Date: 08/23/17  
To: MQ Power Generator Owners  
From: MQ Power Product Department  
Subject: DEF Tank Cover Plate Replacement — **Mandatory Update**

# Service Bulletin

**DCA150SSJU4F, DCA220SSJU4F and DCA300SSJU4F Generators  
DEF Cover Replacement**

<b>Product Group:</b> Power Solutions	<b>Date Issued:</b> 08/23/17	<b>Service Bulletin No.</b> GSP20170818
<b>Bulletin Type</b>  <input checked="" type="checkbox"/> Mandatory  <input type="checkbox"/> Information Only  <input type="checkbox"/> Recommended Change		<b>Models/Series Affected:</b>  DCA150SSJU4F S/N 7601131~7601140 DCA220SSJU4F S/N 8010878~8010997 DCA300SSJU4F S/N 9110041~9110075 AND S/N 9110086~9110095

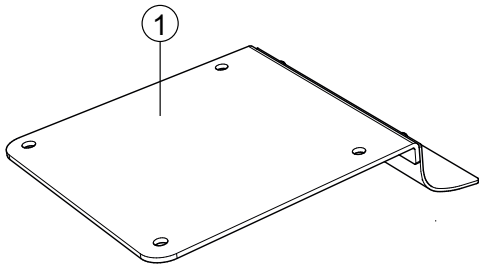
<b>Details</b>  <b>Problem:</b> <p>Hot air flow from the radiator/intercooler blowing directly onto the Diesel Exhaust Fluid (DEF) tank can cause the fluid to become too hot. Temperatures at or above 150° F/ 65° C will cause the Engine Control Module (ECM) to generate a fault code and shutdown the engine.</p> <b>Solution:</b> <p>Install new DEF tank cover plate that includes a rubber flap to <b>block/divert</b> incoming hot air from reaching the DEF fluid inside the tank.</p>
--
